Frame (Defect Inspection) REPORT (hereinafter called the "Report")

Report Number 00024 Time:11:30 AM

Inspection Date: 17/03/2022

Property Address: LOT sample

Figure 3.1.2.2

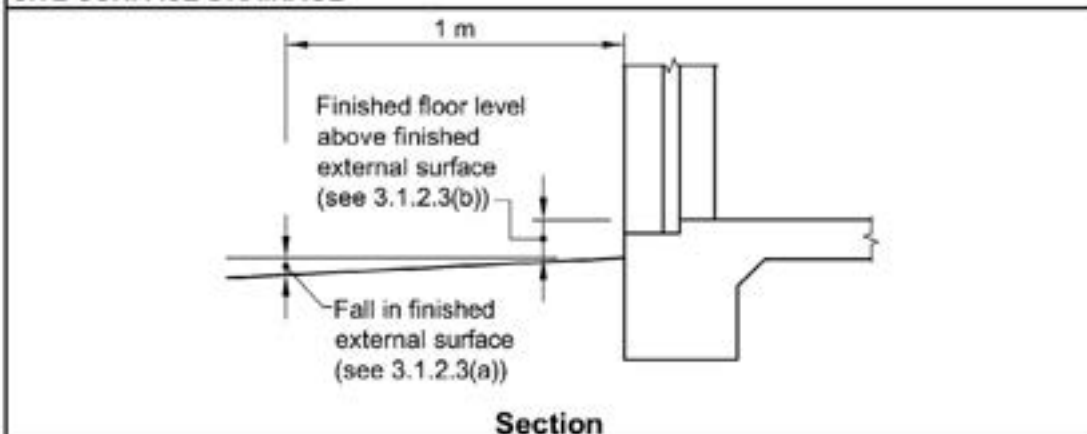
2. The slab footings have the opportunity to pool with water, due to the temporary down pipes not been reinstalled and ground levels not graded away from the home.

Water management on site is paramount to ensuring that the foundations are not damaged. Water, when seeping down beside the slab, between the slab and the dirt softens the dirt. The soils capacity to withstand the downward pressure of the forces of the weight in the slab is greatly reduced. Hence slab failure occurs. The BCA is very clear in its requirements to have the soil graded from the start away from the dwelling as a minimum of 50 mm over 1 m. This has not been done. We refer all to the BCA, part 3.1.2.3.

We also refer the builder to the soil report and engineering drawings that clearly call for the site drainage to be managed via sloping water away from the slab and more so, managing same. The builder must act on this defect now.

- (a) Slab-on-ground — finished ground level adjacent to buildings:
the external finished surface surrounding the slab must be drained to move *surface water* away from the building and graded to give a slope of not less than (see [Figure 3.1.2.2](#))—

- (i) 25 mm over the first 1 m from the building in *low rainfall intensity areas* for surfaces that are reasonably impermeable (such as concrete or clay paving); or

- (ii) 50 mm over the first 1 m from the building in any other case.
- (b) Slab-on-ground — finished slab heights:
the height of the slab-on-ground above external finished surfaces must be not less than (see [Figure 3.1.2.2](#))—

- (i) 100 mm above the finished ground level in *low rainfall intensity areas* or sandy, well-drained areas; or
 - (ii) 50 mm above impermeable (paved or concreted areas) that slope away from the building in accordance with (a); or—

- (iii) 150 mm in any other case.

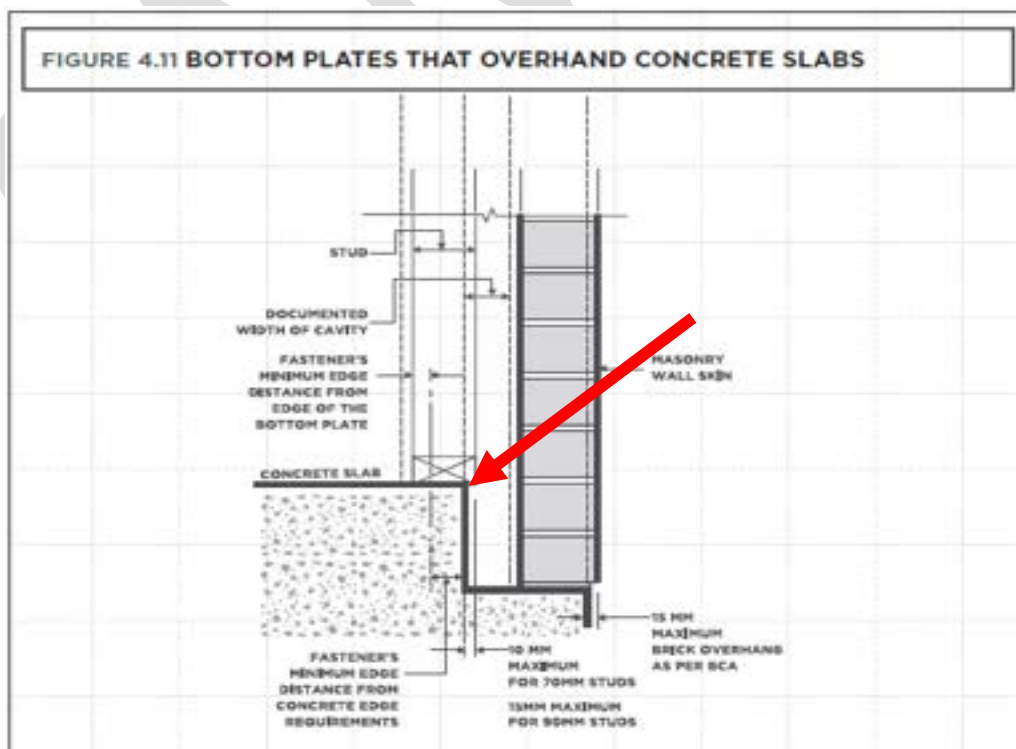
6. The roof penetrations to the sisalation have defects, needs reworking.

Sisalation has to be installed correctly to prevent moisture from transferring to the frame. Areas have over cut thus allowing the transfer of water moisture to the frame, any moisture running down will now exit into the roof void. This will in itself cause additional defects at a later stage. All holes need to be patched to comply with Energy efficiency requirements "Pliable Building Membranes and Underlay's" part 2 states: The only tapes that can be used on sisalation are AS 4254 compliant. Please note that any coloured tapes used on the foil side of the sisalation are defective. The tapes used to this side of the sisalation must be designed for installation on a foil surface and hence AS 4254 compliant.

The pliable building membrane shall be cut neatly to allow penetration by chimneys, vents, pipes, cables and other services, as required.

Where a pliable building membrane is installed as thermal control, penetrations shall be sealed to restrict air exchange between air cavities of either side of the membrane.

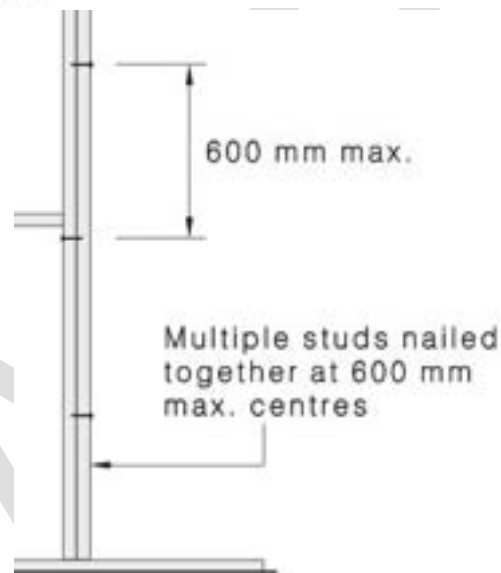
12. There are large gaps to the frame packers, studs/missing, this will need rework, not in an appropriate, skilful way or Multiple studs at sides of openings or in locations supporting concentrated loads shall be laminated together as follows. **AS 1684.2; 2.4**

Nail spacings exceed 600 mm.

- 35 mm studs shall be laminated using 75 mm nails @ 600 mm spacings.
- 45 mm studs shall be laminated using 90 mm nails @ 600 mm spacings.

In the case of studs at sides of openings and studs supporting concentrations of load, the required size may be built up by using two or more laminations of the same timber type, stress grade and moisture content condition, provided the achieved width is at least that of the nominated size. Studs up to 38 mm thick shall be nailed together with one 75 mm nail at maximum 600 mm centres. Studs over 38 mm but not exceeding 50 mm thick shall be nailed with one 90 mm nail at maximum 600 mm centres (see Figure 2.9).

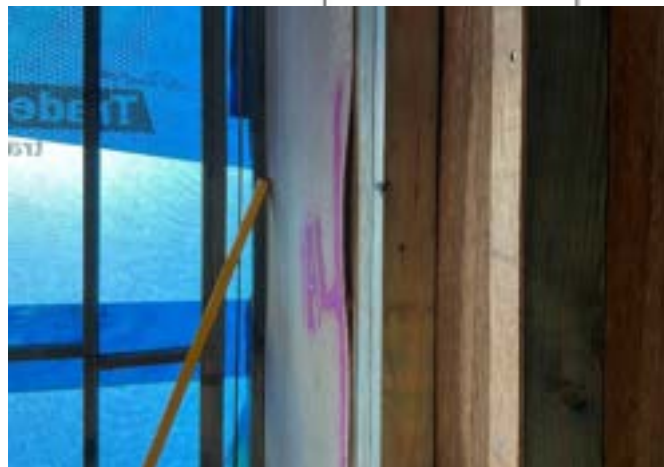
13. There are a number of sheets bracing, not as per plan and sheets have missing nails and loose bracing sheets therefore decreasing the function of the bracing and don't look new. This must be reworked.

The timber sheet bracing installation is a vital structural member in the overall build of the dwelling. It stops the house from moving when racking forces, such as wind, are applied to a dwelling. The installation of the timber sheet bracing on this house is defective for several reasons. The outer sheet edge must be secured at a maximum of top & bottom 50mm edges 150 centres. This dwellings installation fails that requirement. The central studs must all be nailed off at 300 mm centres maximum. We refer the builder to AS 1684.2, table 8.18 on page 143. The requirements stated above are clearly defined and must be rectified prior to moving forward with the dwelling.

(h) Plywood Plywood shall be nailed to frame using 30 x 2.8 Ø galvanized flat-head nails or equivalent.		Minimum plywood thickness, mm	
For Method A, M12 rods shall be used at each end of sheathed section top plate to bottom plate/floor frame. Method B has no rods but sheathing shall be nailed to top and bottom plates and any horizontal joints at 50 mm centres.	Stress grade	Stud spacing mm	
		450	600
Horizontal butt joints are permitted, provided nail fixed to nogging at s = 150 mm centres for Method A, or s = 50 mm centres for Method B	F8	7	9
	F11	6	7
	F14	4	6
	F27	4	4.5
		Fastener spacing (s) mm	
		Top and bottom plate:	
		— Method A	150
		— Method B	50
		Vertical edges	150
		Intermediate studs	300
		Fixing of bottom plate to floor frame or slab	
		Method A: M12 rods as shown plus a 13 kN capacity connection at max. 1200 mm centres	
		Method B: A 13 kN capacity connection at each end and intermediately at max. 1200 mm centres

Method A only: M12 rod top to bottom plate each end of sheathed section Sheathed panels shall be connected to subfloor

FIGURE 6.6 NOGGING

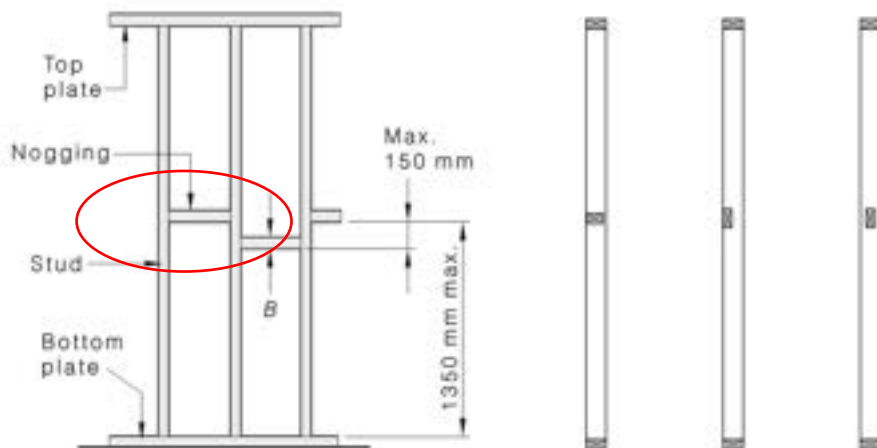
19. Some noggings are missing, loose, too far apart 1350mm and are not continuous, have been marked

There are a number of wall noggings that need to be installed or in parts reinstalled. We refer the builder to **AS 1684.2, clause 6.2.1.5**.

Where required, wall studs shall have continuous rows of noggings, located on flat or on edge, at 1350 mm maximum centres (see Figure 6.6).

FIGURE 6.3 TYPICAL WALL JUNCTIONS

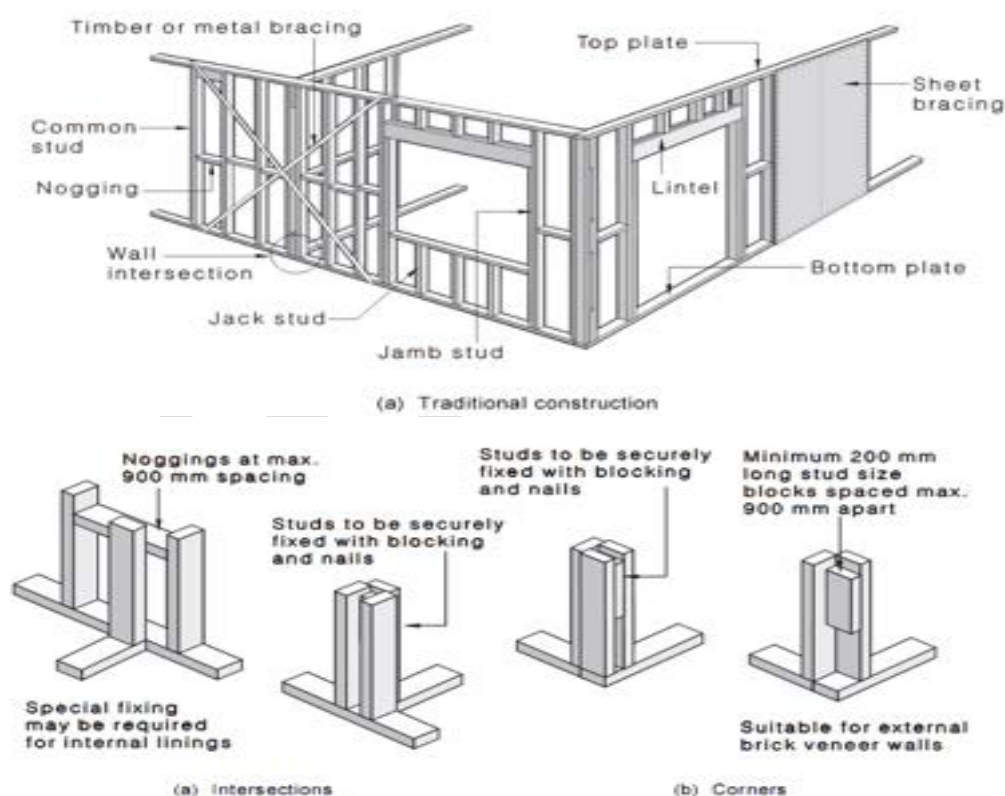
20. Intersecting blocks as marked have not been nailed and some are missing.

This does not comply with the standard, additional nails and blocks will need to be installed as per insert below:

As per figure 6.1 the blocking has not been installed to the underside of the top plate and hard up to the underside of the bottom plate.

Please note the use of a corner stud does not negate the need for blocks. As clearly shown in part (b) of figure 6.3.

AS 1684.2 mandate that the blocks are a minimum of 200 mm long and max centres of 900 mm and nailed with 2/75 mm nails.

All intersecting walls shall be fixed at their junction with blocks or noggings fixed to each wall with 2/75 mm nails. Blocks or noggings shall be installed at 900 mm max. centres.

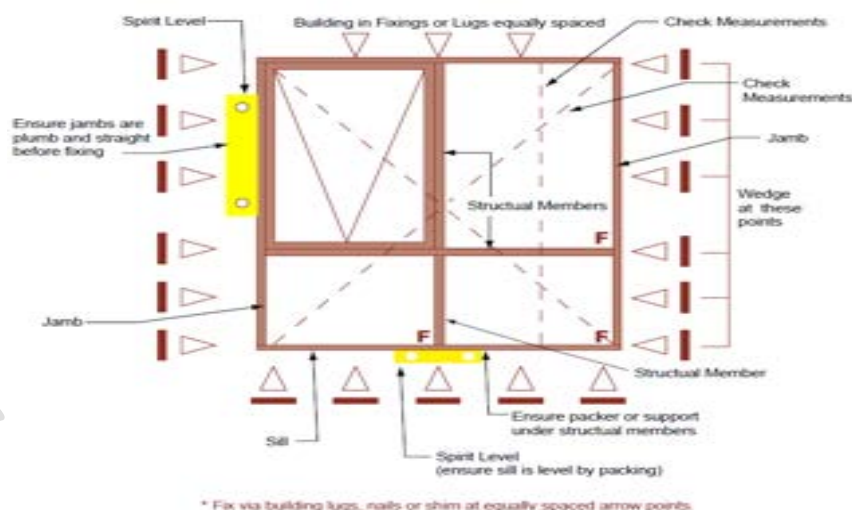
22. Some of the window/door frames have not been packed, not installed to the manufacture's installation guide as per below, this will need to be rectified.

3. Frame must be packed plumb, square and not twisted between the openings. Ensure the sill is fully supported. Failure to do so may result in sill roll on sliding windows.

Sills on all windows and doors must be straight and level and should be packed and secured.

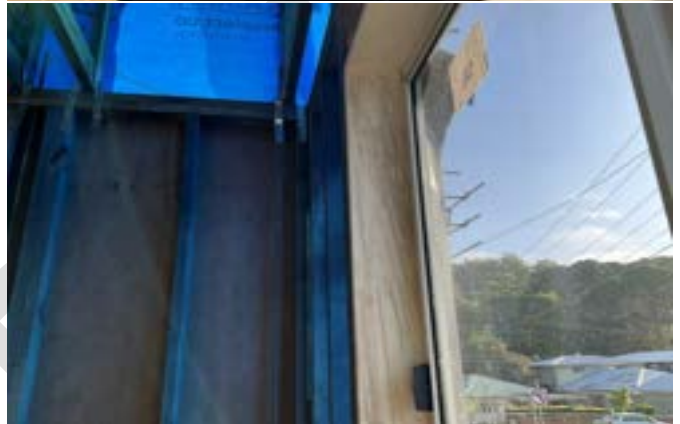
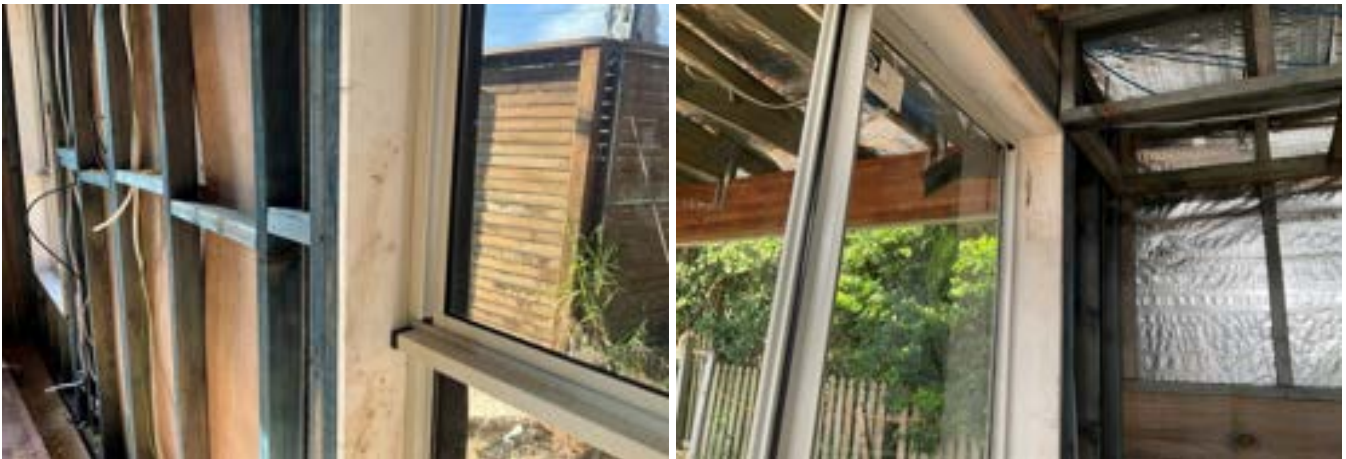
23. It appears that the window frames for the house have exposed to the weather moisture. As per AS 2047 inserted, some of the windows are now be defective and will need to be made “as new” prior to installing.

Windows should be stored on site in a clean, dry area away from the damaging effects of cement, lime, paint, acid and the like. During installation, they should be protected from building fallout such as wet plaster, mortar, paint and welding splatter. Wet plaster and mortar should be removed immediately and the soiled area washed down with clean water. If removal is delayed and scraping becomes necessary, the surface finish might be damaged.

Acid used for cleaning brickwork should be prevented from dripping onto aluminium. If this dripping onto aluminium occurs, the acid should be immediately washed off with clean water.

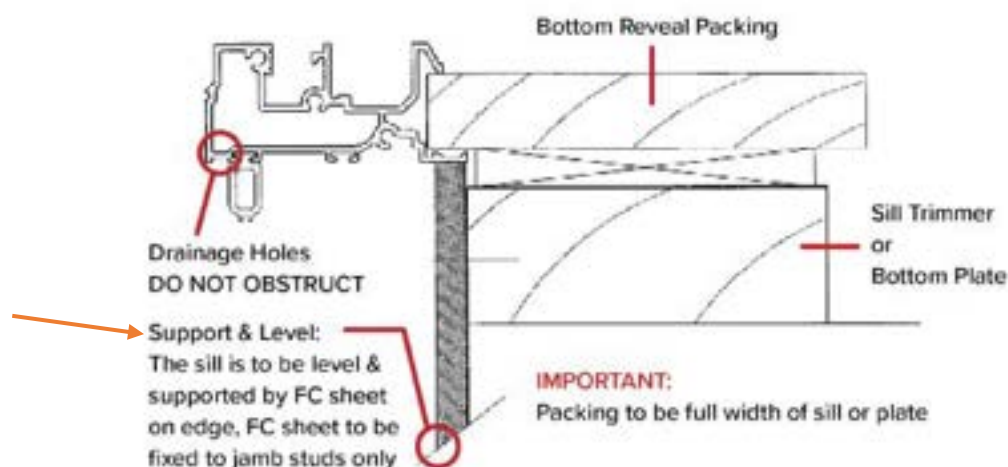
24. Windows/door openings, reveals are bowed, there should be suitable packing material to support the load of the window/glazer, and packing shouldn't deform the window in anyway.

We refer the builder to AS2047. Will need to be reworked.

Openings in buildings into which windows are to be installed shall be of sufficient size to allow the window frame to be installed level and plumb.

Window assemblies shall be fixed into the building using recognized building practices. Fixing shall not deform the window assembly. Non-loadbearing window assemblies shall not carry building loads.

TABLE 9.20
UPLIFT CAPACITY OF BEAM/LINTEL TIE-DOWN CONNECTIONS

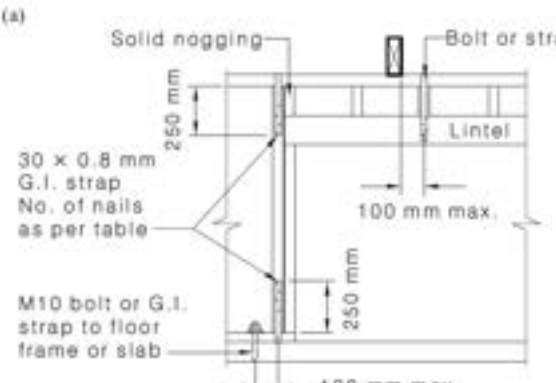
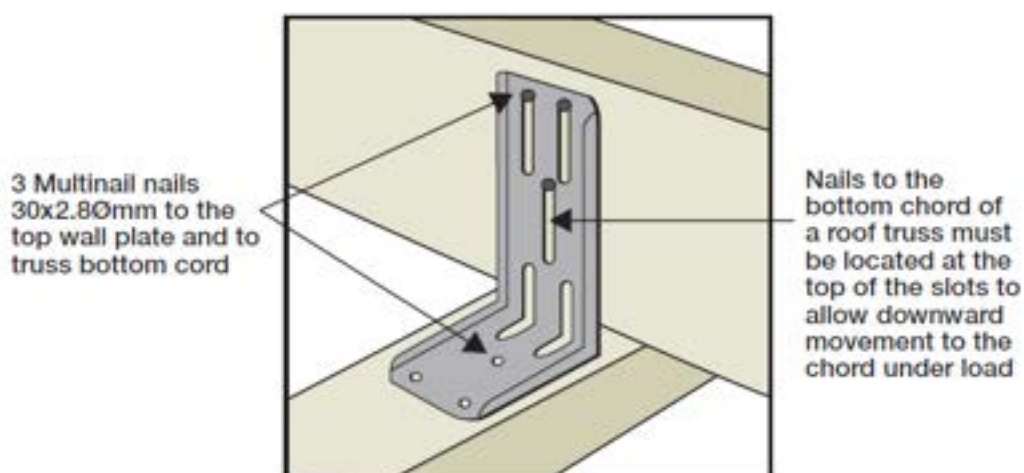
26. It appears that no strapping/ tie down for the top plate to lintel as been installed. As it states in table **9.20 Uplift capacity of beam/lintel tie down connections**, that top plate shall be fixed to lintel within 100mm of each rafter/truss or fixed to the lintel with a fixing of equivalent tie-down strength.

The top plate shall be fixed or tied to the lintel within 100 mm of each rafter/truss, or the rafter/truss fixed directly to the lintel with a fixing of equivalent tie-down strength to that required for the rafter/truss.

FIGURE 2.3 FIXING OF TRUSSES TO FREESTANDING NON-LOADBEARING WALL THAT IS NOT A BRACING WALL

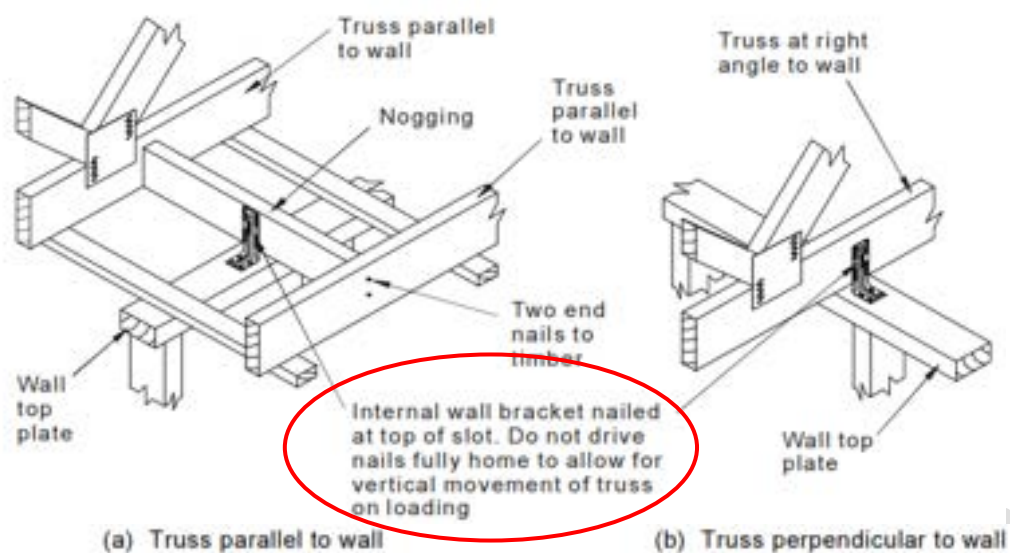
28. It appears that some of the L-brackets have been over driven, this doesn't not comply, see insert below for further information.

- (c) *Non-bracing wall* For an internal non-loadbearing wall not designated as a bracing unit, stability of the wall shall be required to resist normal applied force, e.g., when closing doors. The top plate of the wall shall be stabilized at maximum 1800 mm centres. Where trusses are parallel to the wall, nogging shall be used in between the bottom chords and fixed to the bracket. Figure 2.3 gives an example of fixing details.
